Addendum Number One

Drawings and Specifications Dated August 17, 2007

Portland Harbor Hotel Annex

Archetype, P.A.

<h1>E1.2</h1>	NEW DRAWING	Date 31 August 2007	Scale SEE DETAIL	ARCHETYPE, P.A. ARCHITECTS 48 Union Wharf Portland, Maine 04101 (207) 772-6022 Fax (207) 772-4056
	Project: PORTLAND HARBOR HOTEL ANNEX	NORTH ELEVATION BUILDING LIGHTING		
	468-470 FORE STREET PORTLAND, MAINE

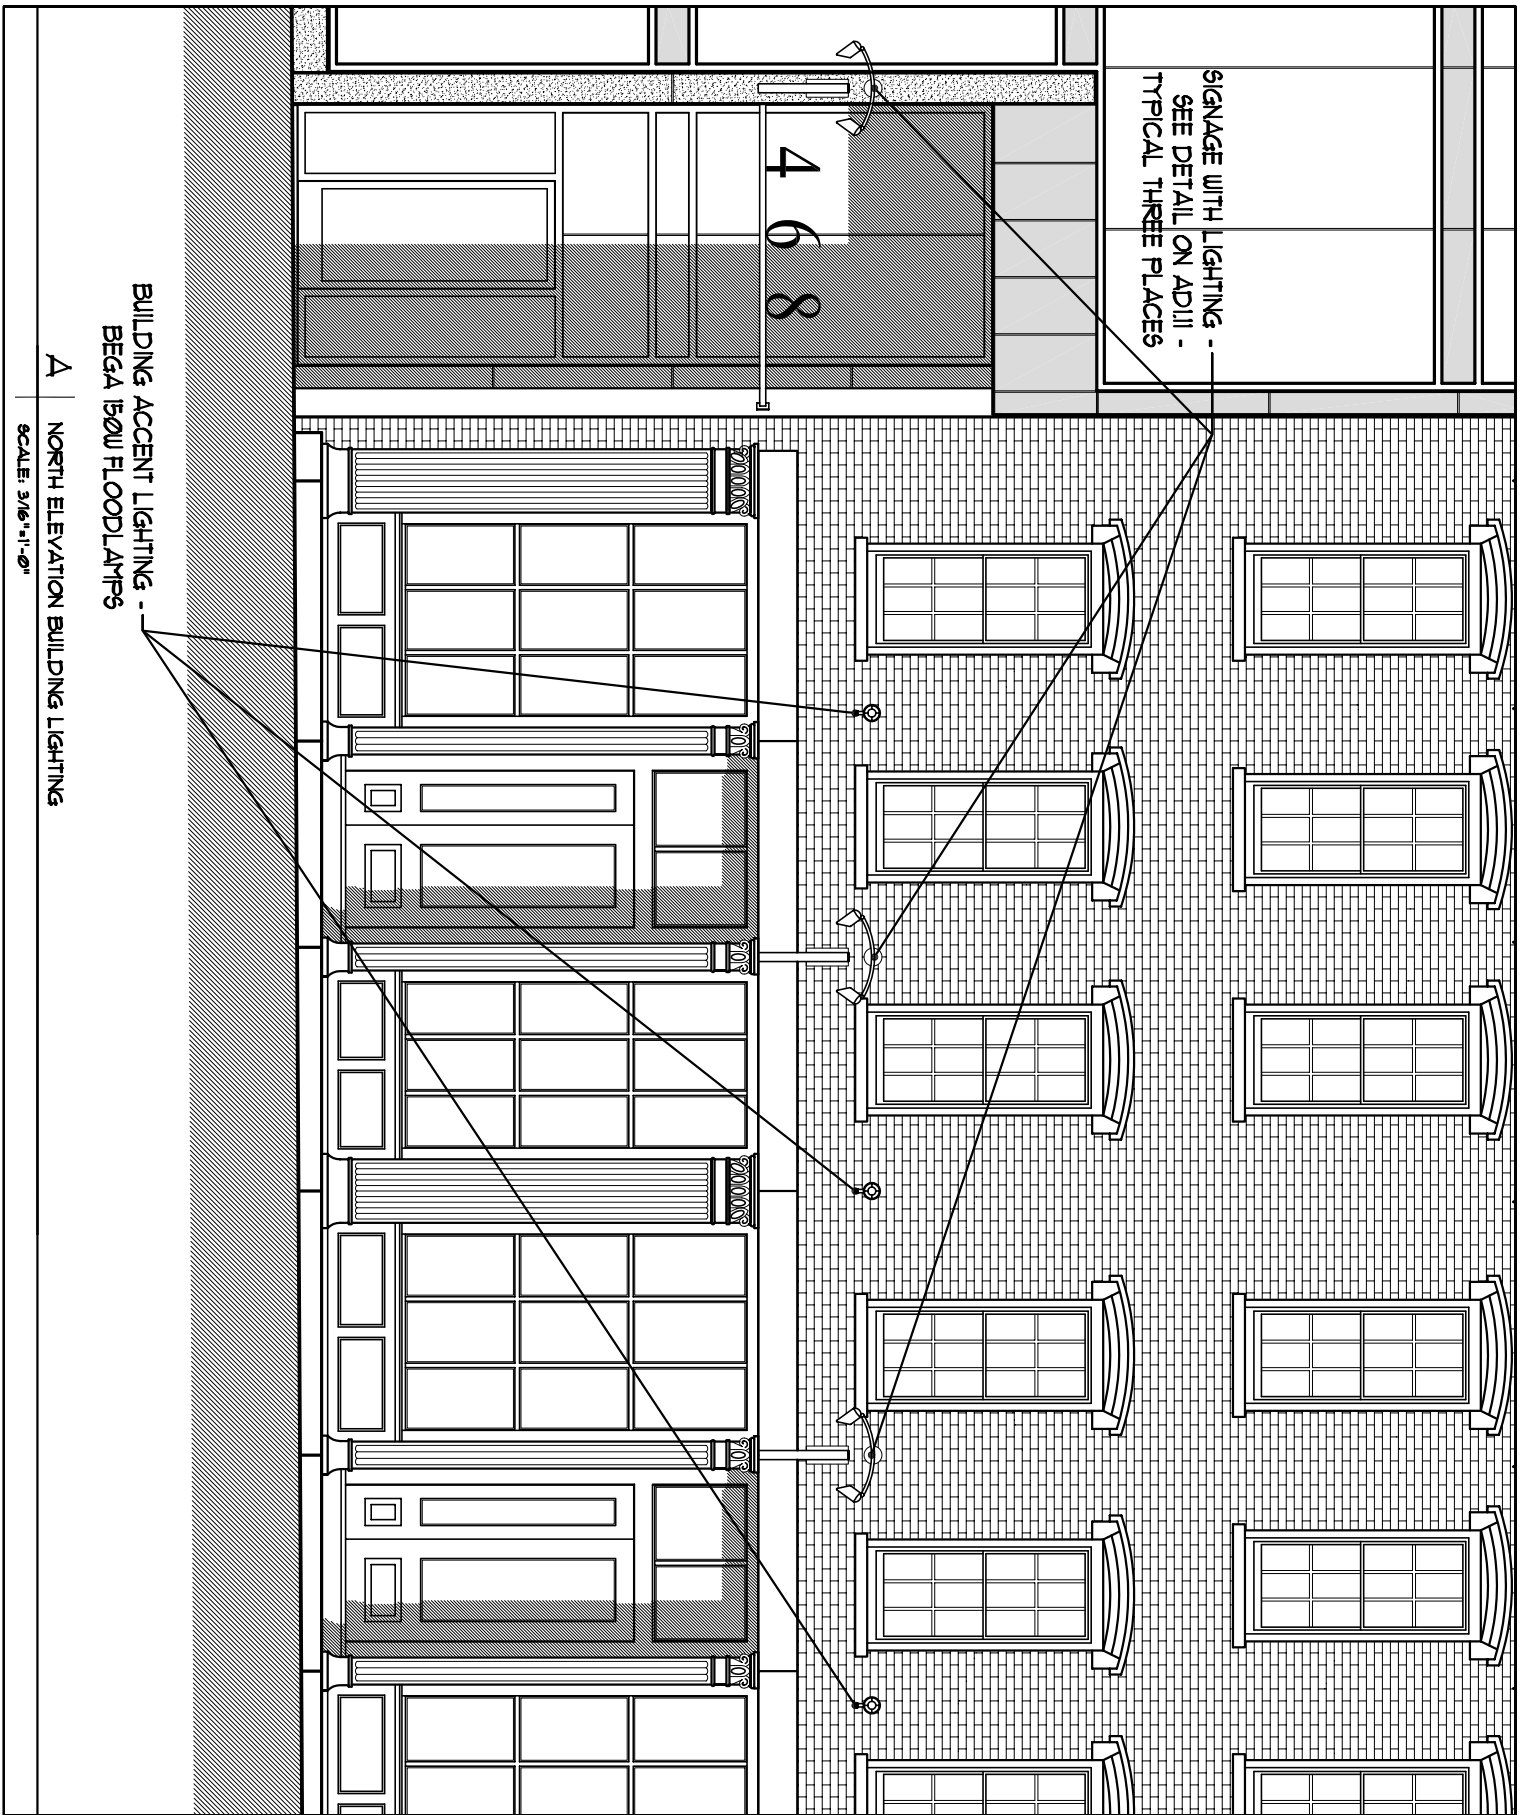
13. **Modification:** Add to drawing set attached sheet **E1.1 – Lighting Plan Ground Floor**, sheet **E1.2 – North Elevation Lighting** and accompanying table of fixtures (3 sheets). These lights and locations are to be carried by electrical subcontractor and associated work for preparation is to be coordinated by General Contractor.

PLAN DETAIL
 NORTH ELEVATION

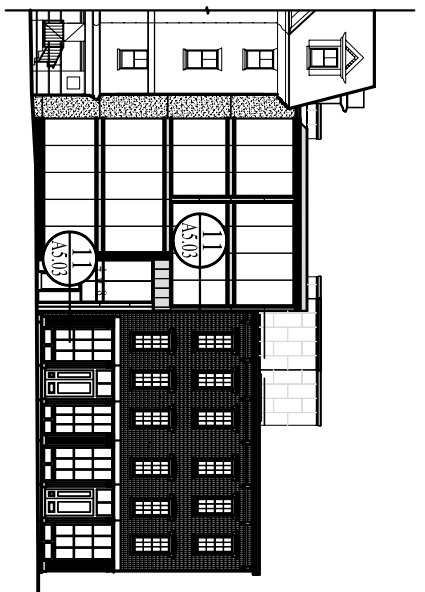
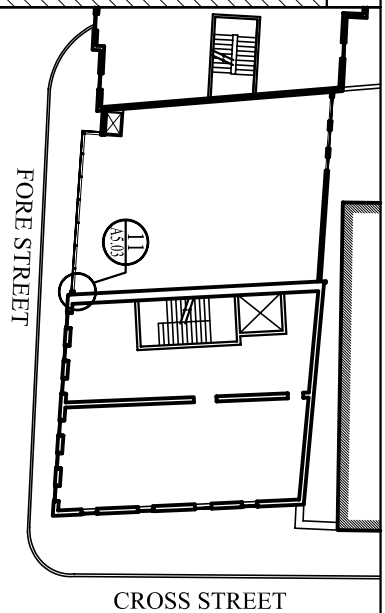
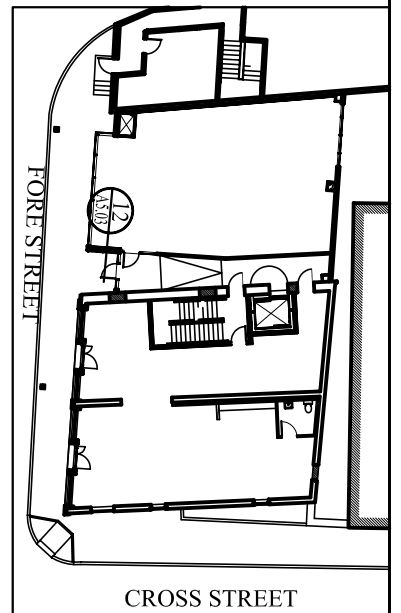
4. **Clarification:** Sheet A5.03 – Details; See accompanying drawing **AD1.1 – Plan Detail North Elevation** for additional detail 11/A5.03 for connection of new north façade curtain wall to existing brick wall.

CLARIFICATION OF CONNECTION BETWEEN NEW CURTAIN WALL AND EXISTING BRICK WALL

SILL DETAIL
GRANITE WALL
ENTRY VESTIBULE

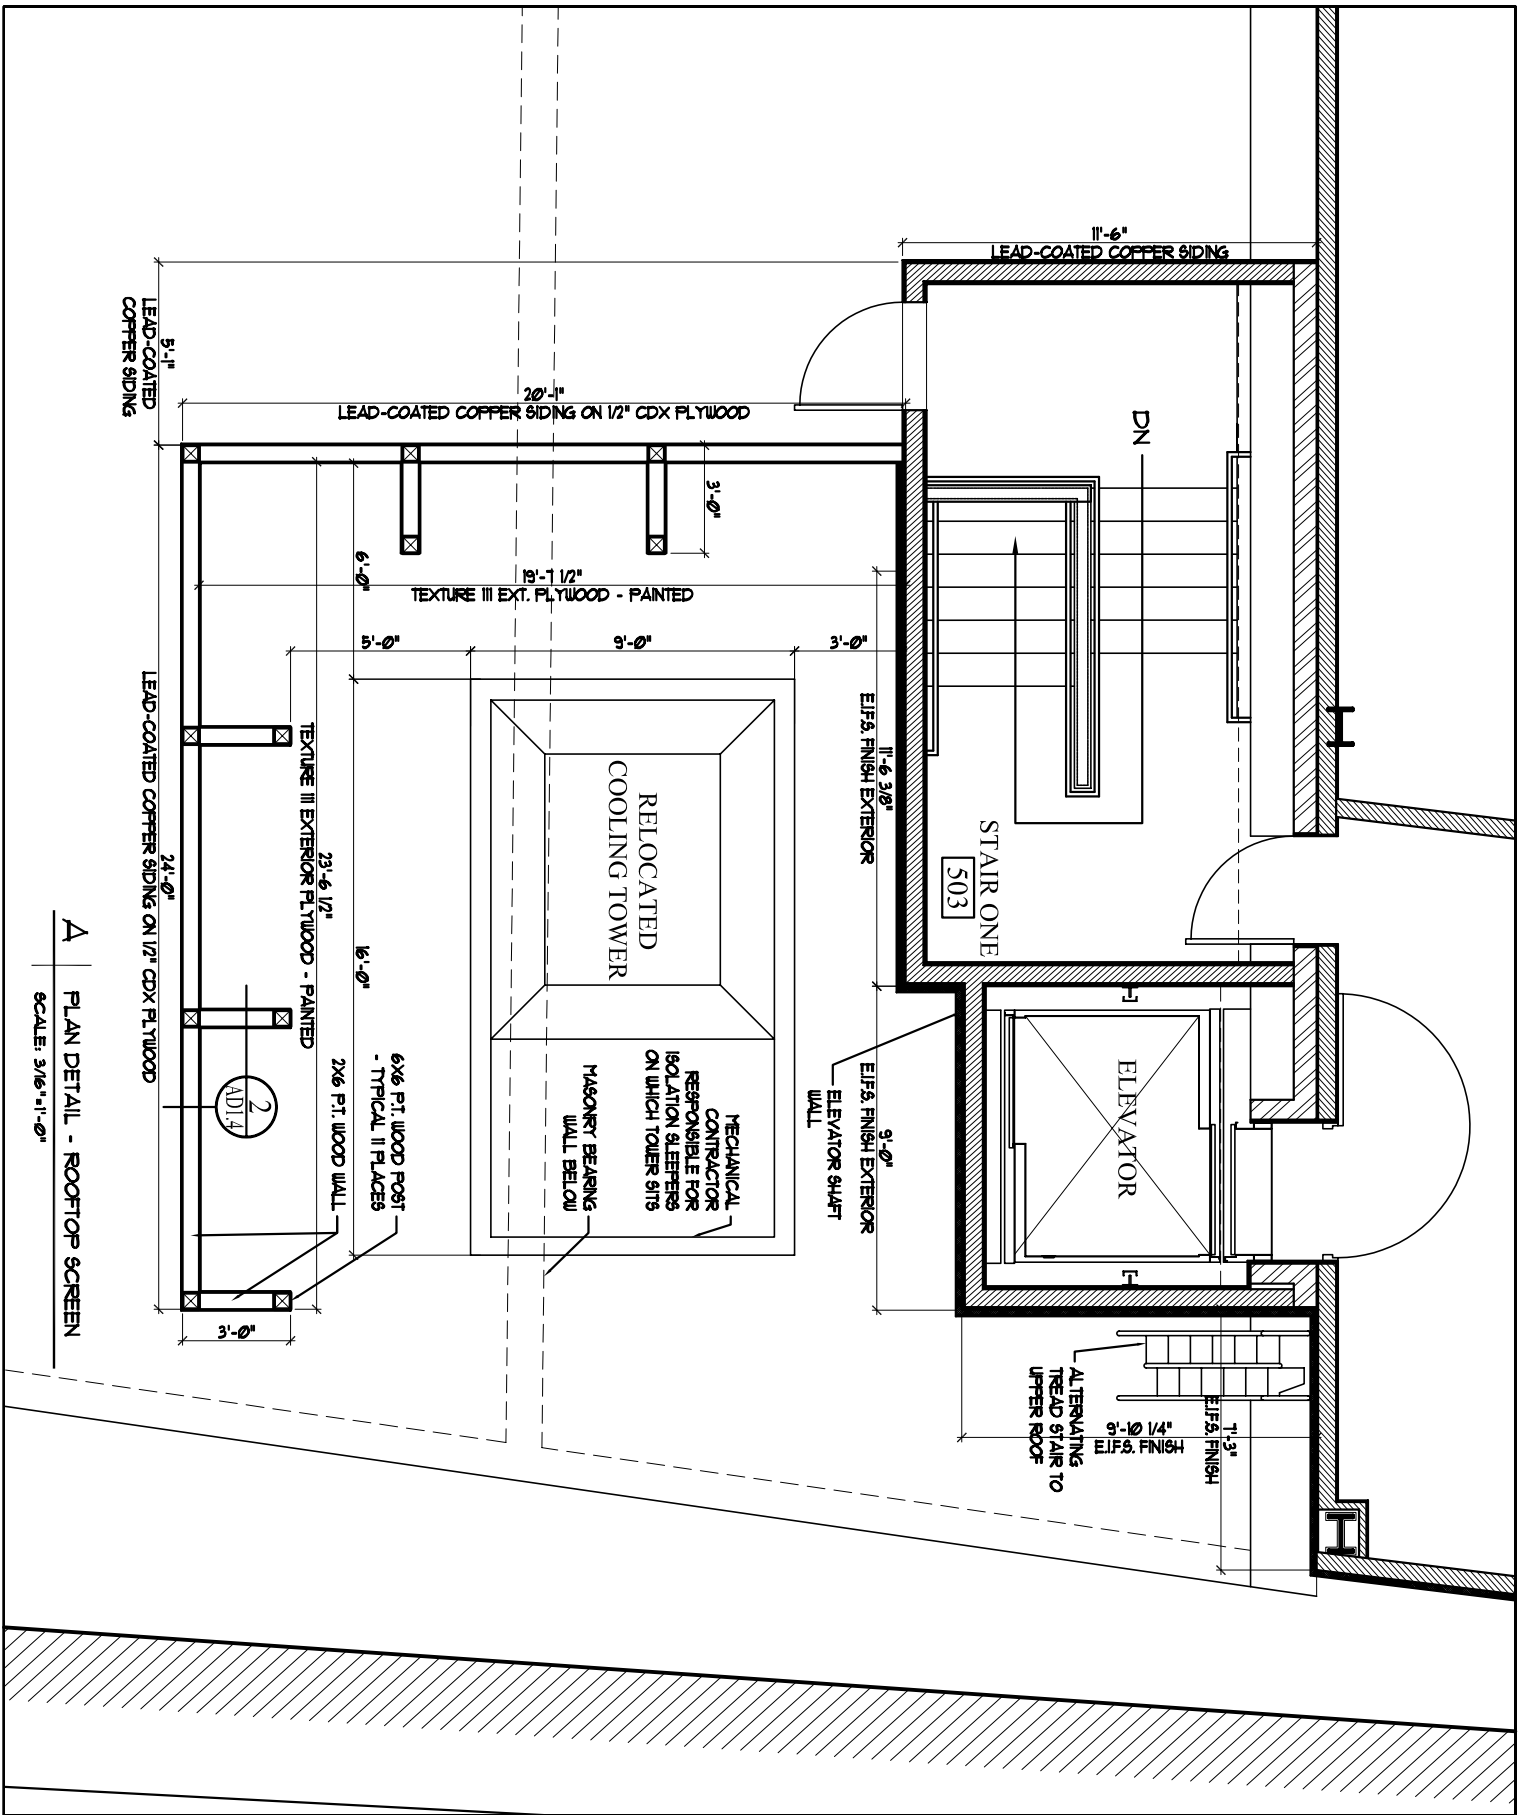
5. **Clarification:** Sheet A5.03 – Details; See accompanying drawing **AD1.2 – Sill Detail Granite Wall** for additional detail 12/A5.03 for granite panel sill detail.

CLARIFICATION OF SILL
DETAIL AT GRANITE
PANEL WALL AT ENTRY
VESTIBULE

AD 1.3	ADDENDUM TO SHEET A1.05		Date 31 August 2007	Scale SEE DETAIL
	Project: PORTLAND HARBOR HOTEL ANNEX		ROOFTOP SCREEN PLAN	
	468-470 FORE STREET PORTLAND, MAINE			
ARCHETYPE, P.A. ARCHITECTS			48 Union Wharf Portland, Maine 04101 (207) 772-6022 Fax (207) 772-4056

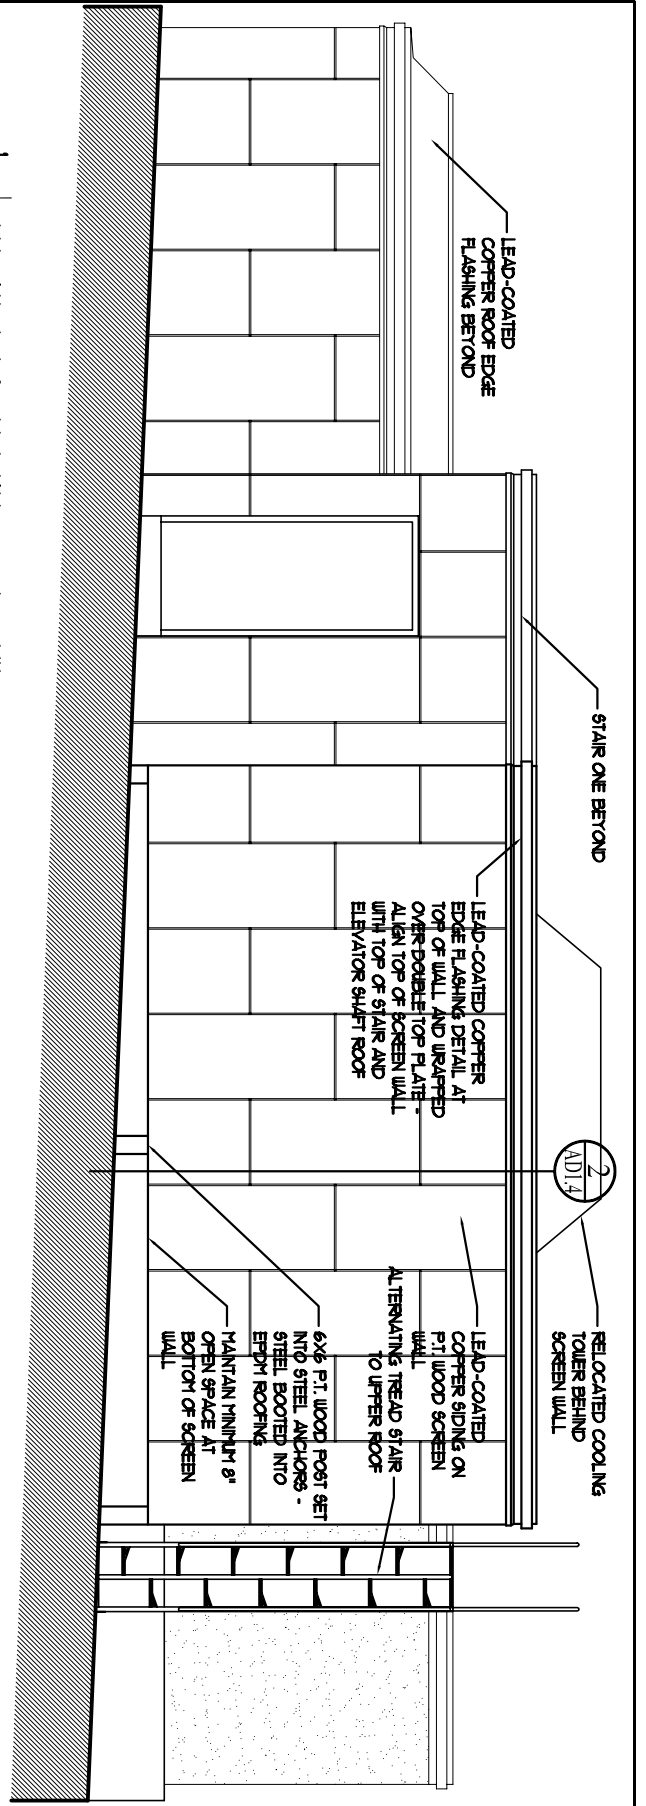
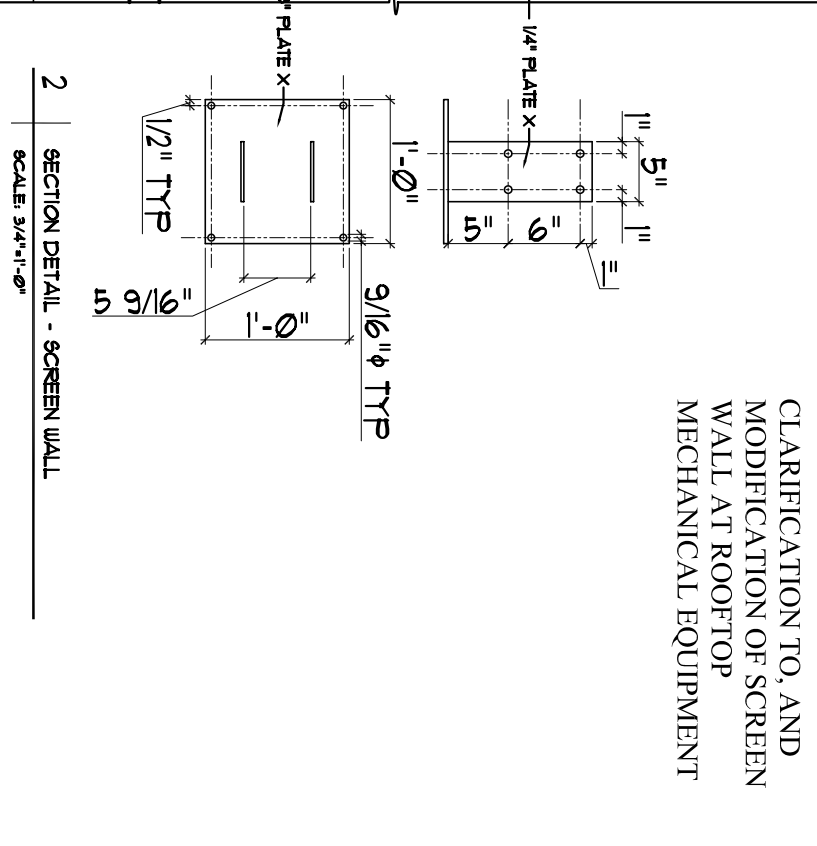
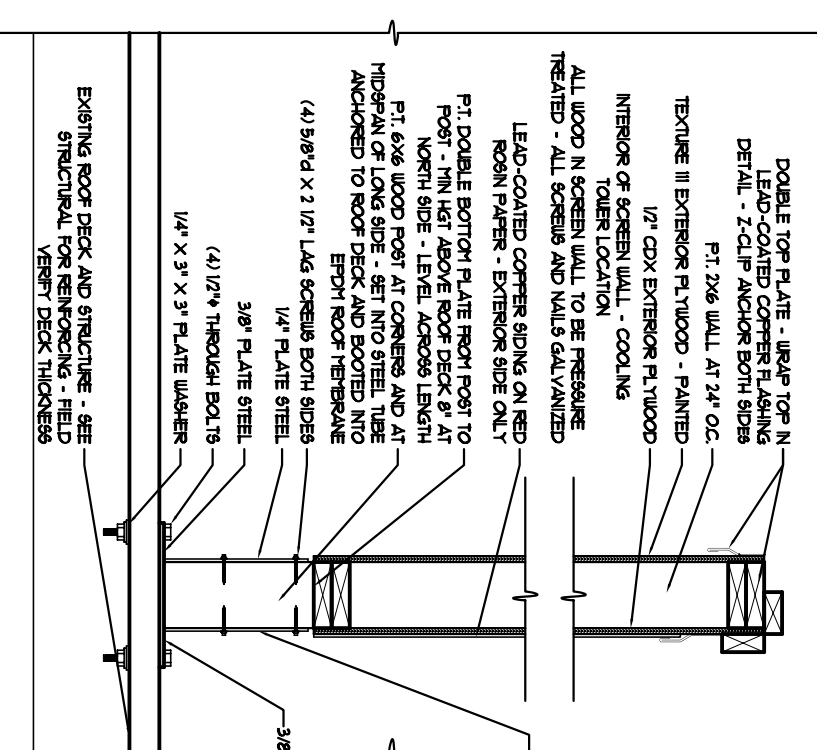
7. **Modification & Clarification:** Sheet A1.05 – Third Floor Plan, Rooftop Mechanical Equipment Screen; see attached drawings **AD1.3 – Rooftop Screen Plan**, and **AD1.4 – Section Detail Screen Wall**, for location, dimension and construction of screen wall around mechanical equipment. Note changes to exterior siding materials on elevator and stair shaft walls as related to location and orientation of screen wall. All siding that will be visible from the street level shall be lead-coated copper. The remainder will be finished with E.I.F.S.

CLARIFICATION TO, AND MODIFICATION OF SCREEN WALL AT ROOFTOP MECHANICAL EQUIPMENT

Date
31 August 2007
Scale
3/8" = 1'-0"
ALTERNATING
TREAD STAIR TO
UPPER ROOF

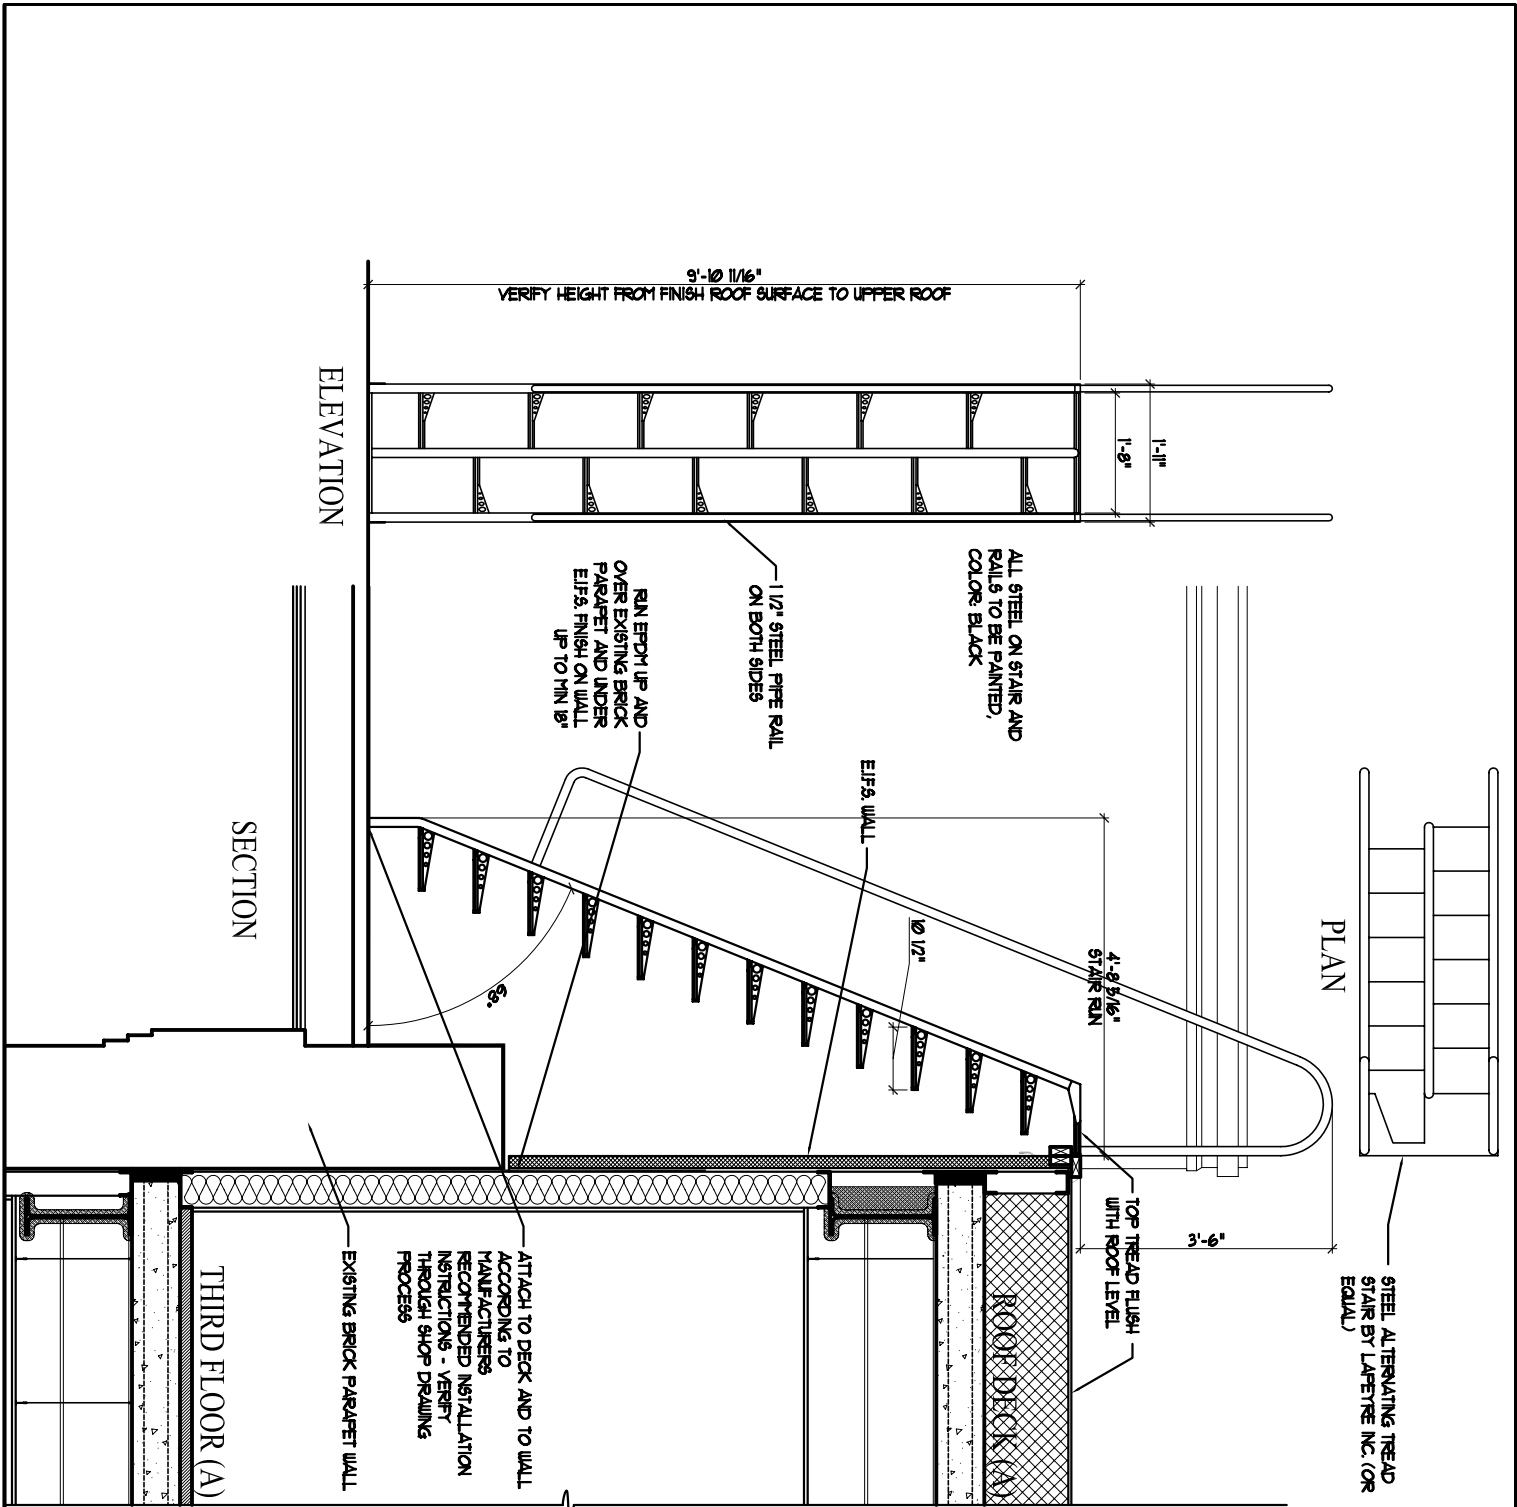
8. **Modification:** Sheet A1.05 – Third Floor Plan and Sheet A1.06 – Roof Plan; See attached drawing **AD1.5 – Alternating Tread Stair** for details to add a painted steel alternating tread stair for access to upper roof from lower roof at south side.

ADDITION OF
STAIR FOR ROOF
ACCESS
